PRELIMINARY FLOOR PLAN  
OFFICE CONTROL ROOM  
MOC-01

ELEVATIONS & DRAWING LIST  
OFFICE CONTROL ROOM  
MOC-01

PROJECT NAME: Murphy Oil Cadotte 1780-025

DOCUMENT DESCRIPTION: Millwork #2 Office Control Room  
MOC-01

FLOOR PLAN  
OFFICE CONTROL ROOM  
MOC-01

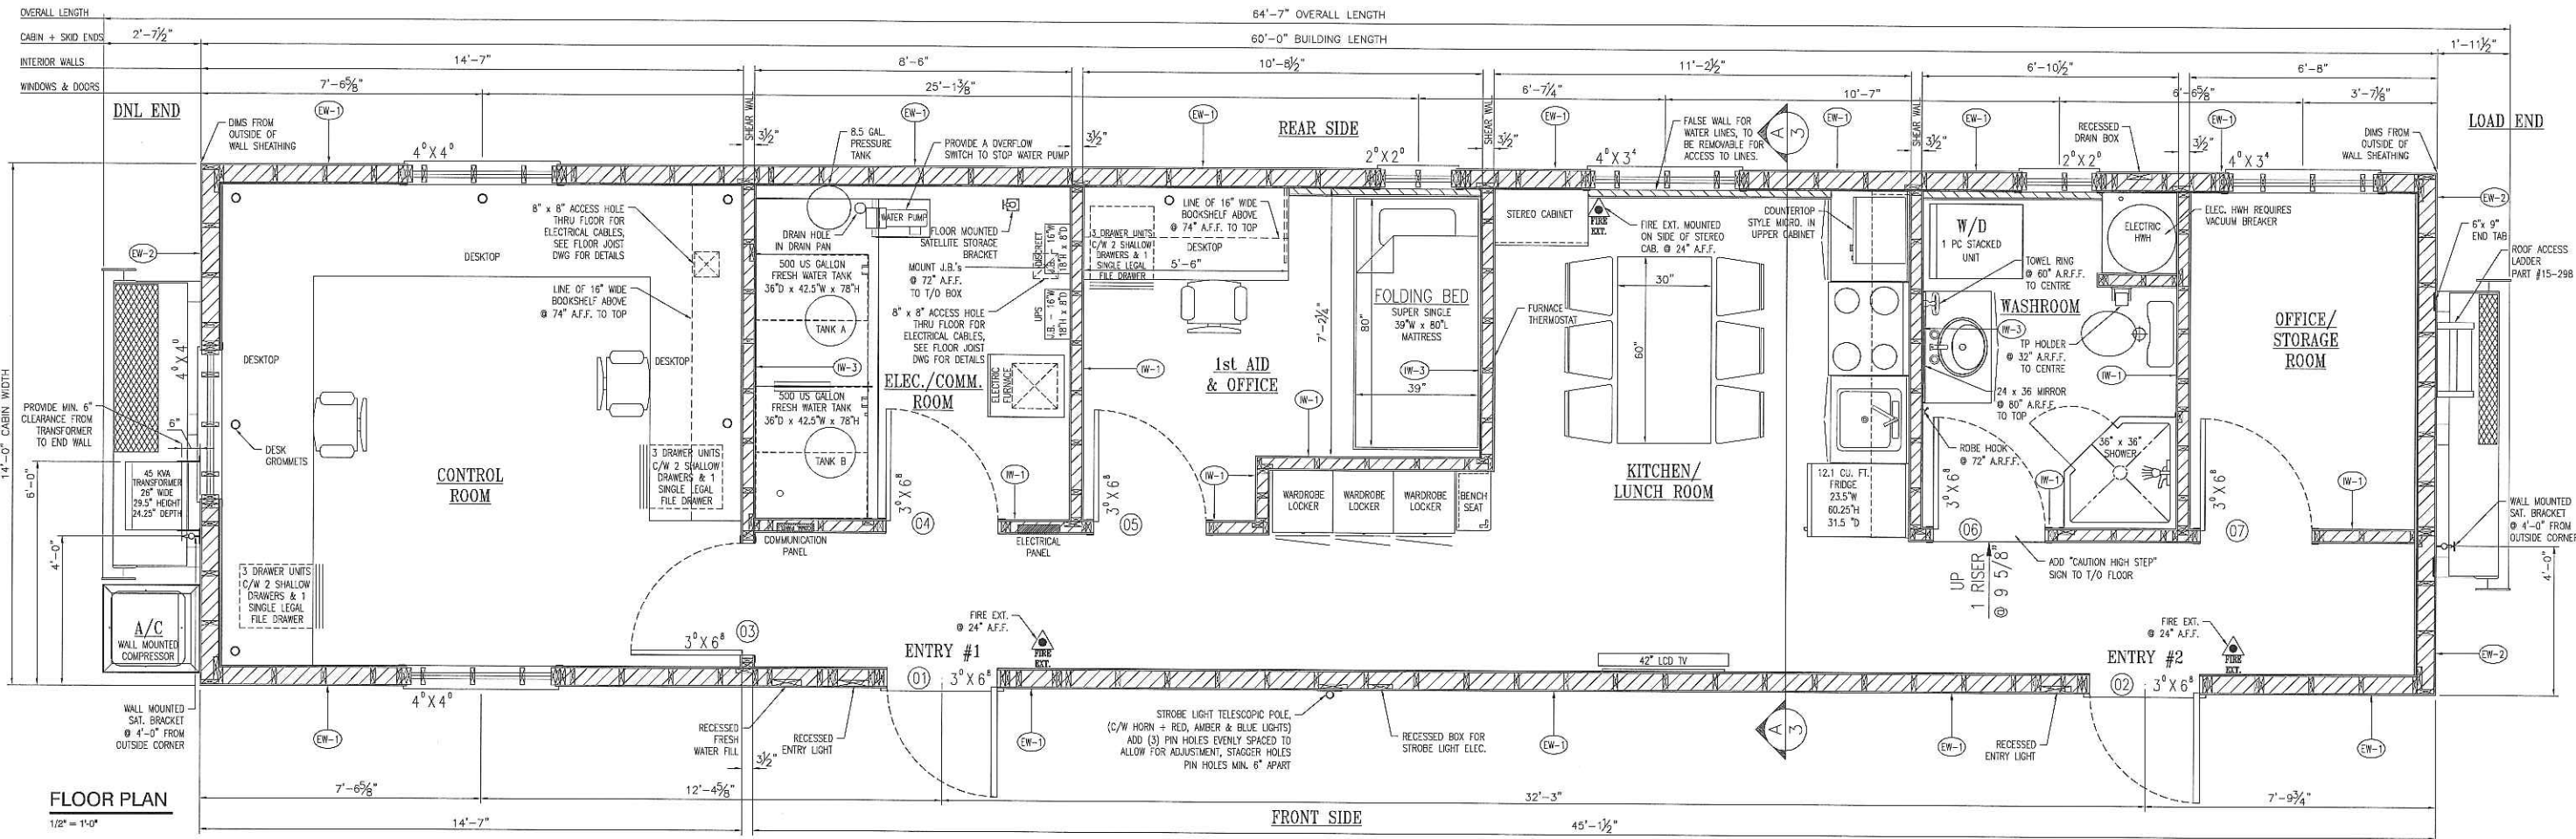
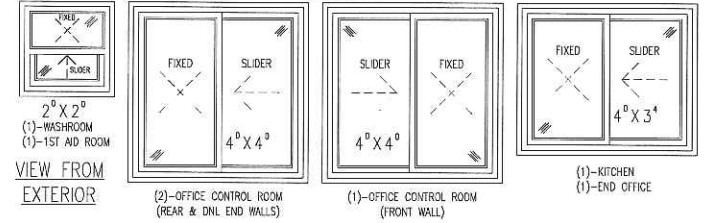
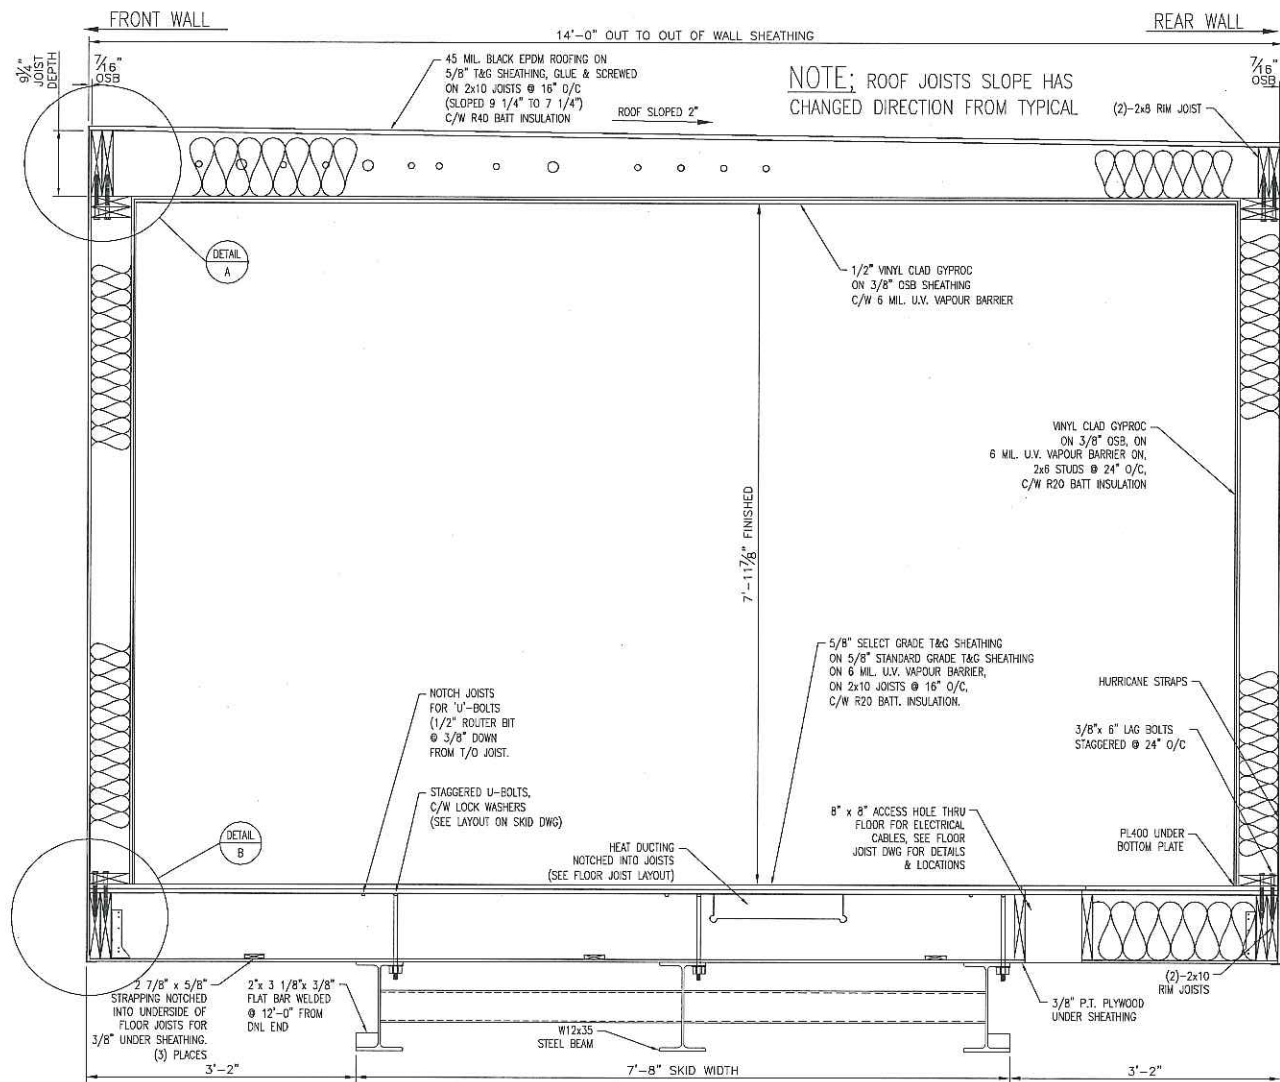
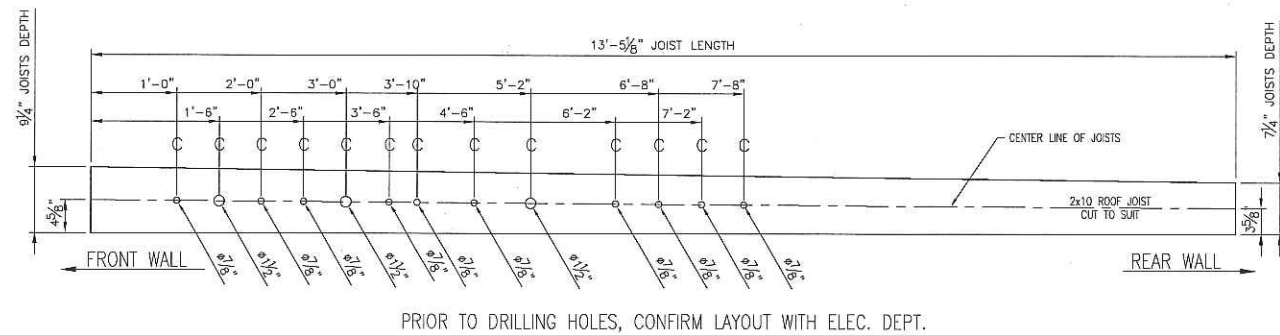
REV # DESCRIPTION DATE  
REV A ADDED SINGLE BOWL SINK, MOVED STROBE LIGHT POLE, ADDED TRANSFORMER APR. 08/12  
REV B UPDATED AS PER CLIENT MARK-UP'S APR. 10/12  
REV C UPDATED TRANSFORMER SIZE APR. 26/12
